Dominic Adams  
Australian Energy Market Commission  
PO Box A2449  
Sydney South NSW 1235

**National Electricity Amendment (Generator Technical Performance Standards) Rule 2017 (ERC0222)**

Figure 1: Comparison of responses where P can reduce to provide reactive power down to a power factor of 0.8 for a sustained remote voltage depression. In this case, the HV bus voltage is 2% higher when allowing the reduction in active power, but does not meet the definition of CUO.

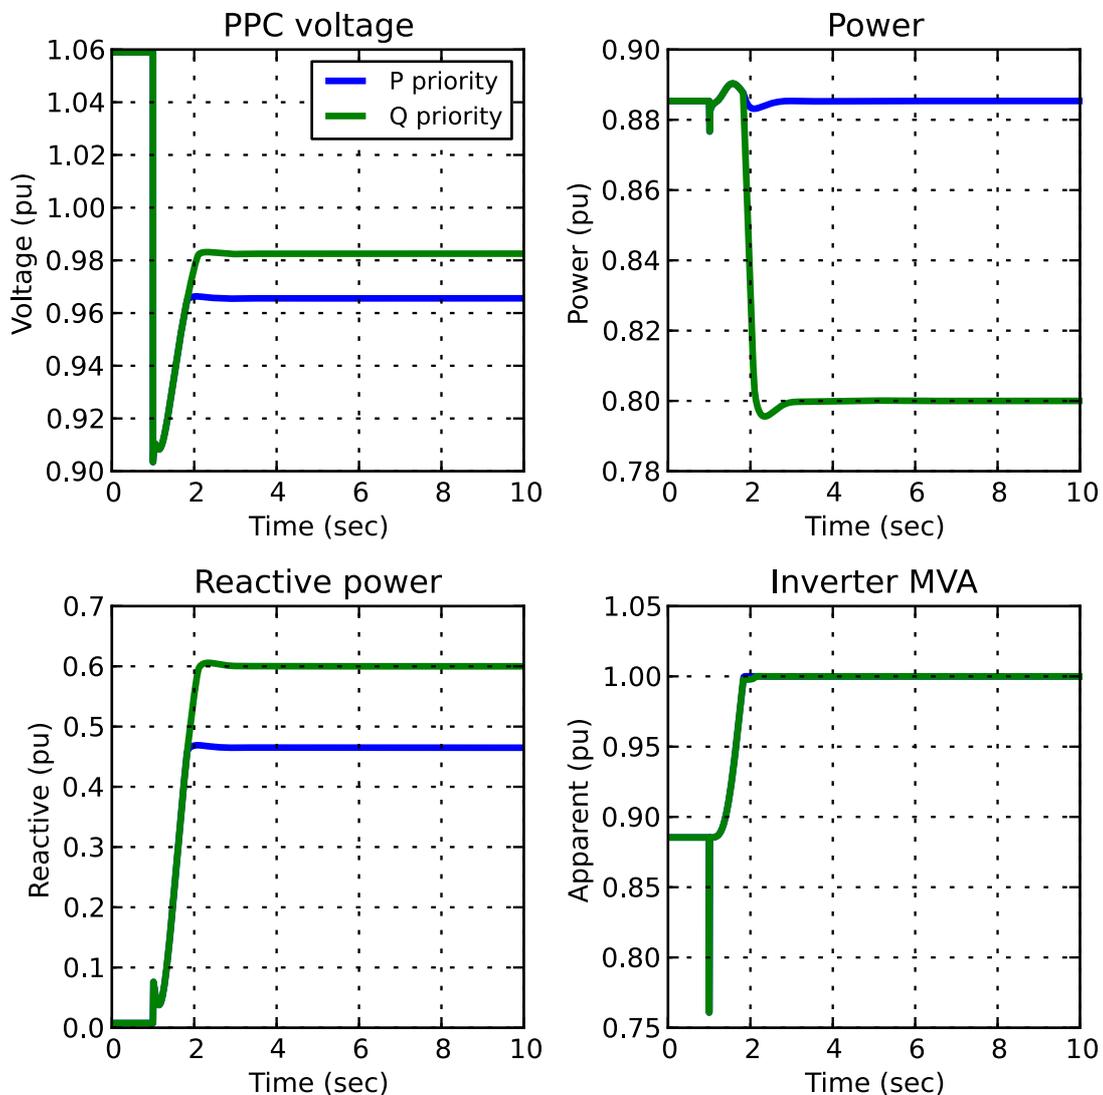
The rationale for why a generator must maintain pre-contingent active power output for an event where the connection point voltage goes to 90% of the normal voltage indefinitely, and at any time, has not been made clear. ESCO Pacific is not aware of a precedent or a credible contingency for which the transmission or most distribution network voltages remain at 90% up for any significant length of time, barring the event being a precursor to a system collapse. Compounding this is the fact that power system elements are usually operated at voltages of around 102% to 105% of the normal voltage, so in practice the voltage drop that generators must withstand is 12% to 15%.

In terms of power system stability, this requirement to maintain active power comes at a cost of providing reactive power to the network, which is required to support network voltages. As such, it seems counterintuitive to restrict the provision of reactive power when the network voltages are low for the sake of preventing even a small reduction in active power output.

To demonstrate the impact of the new interpretation, Figure 1 above shows the response of two identical generating systems, one where the control system maintains active power output and the other where the controller will allow active power output to reduce to provide reactive power for voltage support. In the case where active power must be maintained the POC voltage is 2% lower than if the generator were able to reduce active power output to provide voltage support to the system.

Since frequency control is a system-wide issue and voltage control is a local issue, it does not make sense to limit the reactive power response of generator to a local voltage issue for the sake of a relatively small amount of active power which could be dispatched from elsewhere.

ESCO suggest the following changes are made to the definition of CUO and the requirement under S5.2.5.4:

- The proposed changes to the minimum access standard for S5.2.5.1 are adopted to ensure new generators have some voltage control capability.
- The previous interpretation of CUO is retained and clearly defined in the NER
- For a voltage disturbance of less than 5% at the connection point from the “normal voltage” (being the voltage that the element normally operates at, distinct from the *nominal voltage* or the *normal voltage* as defined in the NER), active power should be maintained at the pre-disturbance power.
- For sustained voltage disturbances of more than 5% at the connection point, the generating system can reduce its active power output by up to 20% (or other suitable figure) to provide reactive power for voltage support during the disturbance.

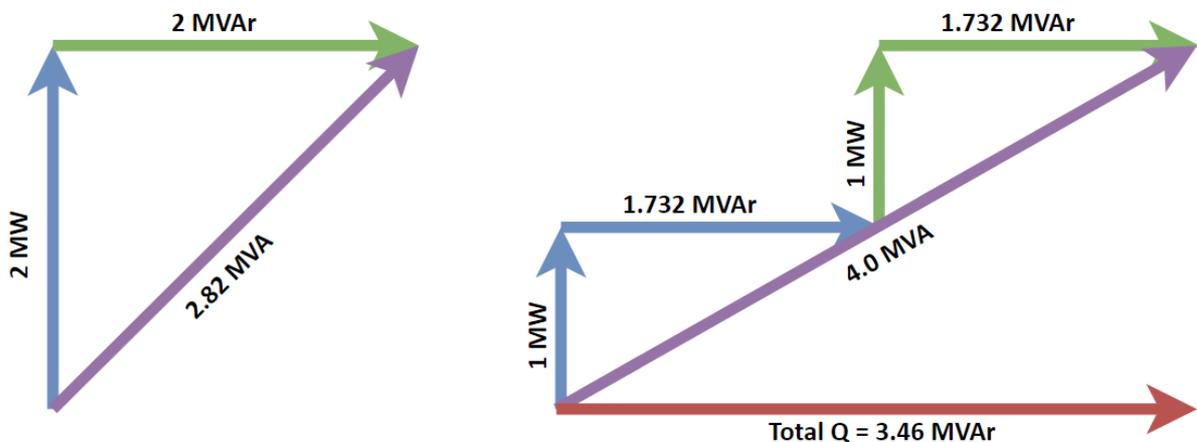
In a hypothetical example given here, the new definition of CUO is applied to a solar farm which is already under construction and additional inverters are required to account for the derating at lower voltages as this was not accounted for in the initial design.

The most efficient method utilizing inverters is to ensure each inverter is evenly loaded with active power output to obtain the maximum reactive capability from the overall system, as shown in Figure 2 below. If a project is already under construction, it will then require significant rework and potential reconstruction of the solar farm reticulation network, inverter placement etc., resulting in delays in commissioning and potential liquidated damages as previously mentioned.

#### S5.2.5.7

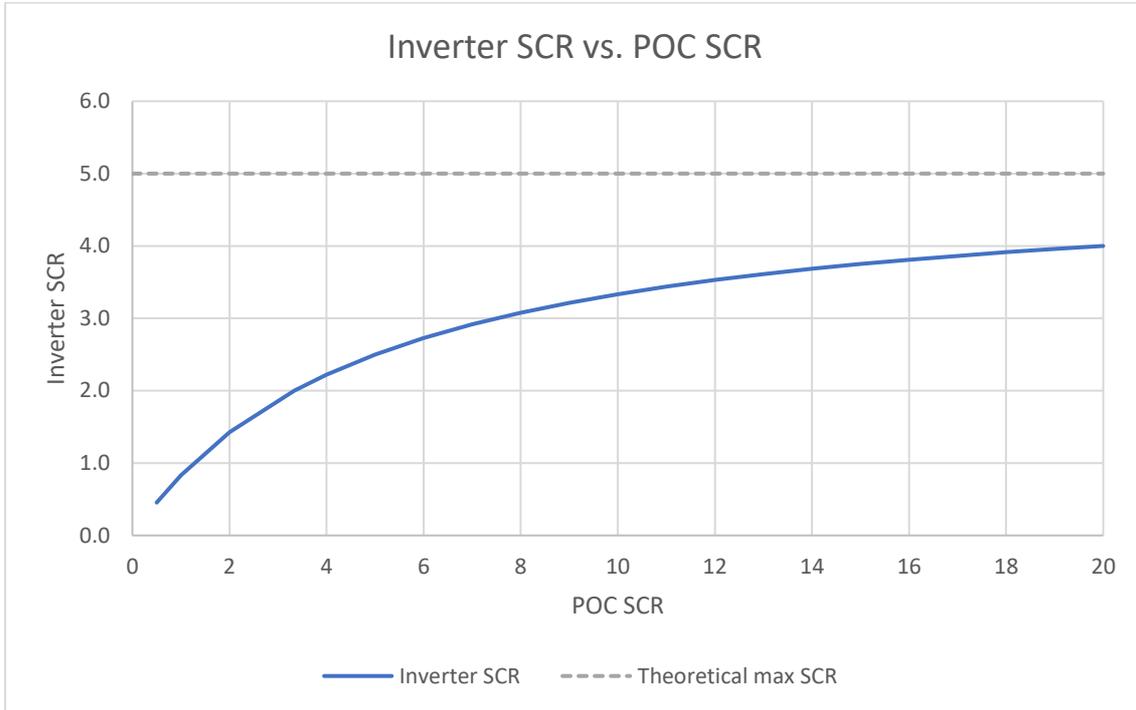
It does not make sense to expect a generator maintain its active power output (as required by the new definition of CUO) should the system load reduce by 30% of its initial level. Regardless, it has never been particularly clear what this clause seeks to achieve which is not already covered in other performance standards – mainly S5.2.5.3, S5.2.5.4 and S5.2.5.11. ESCO recommended that this performance standard is removed from the NER all together.
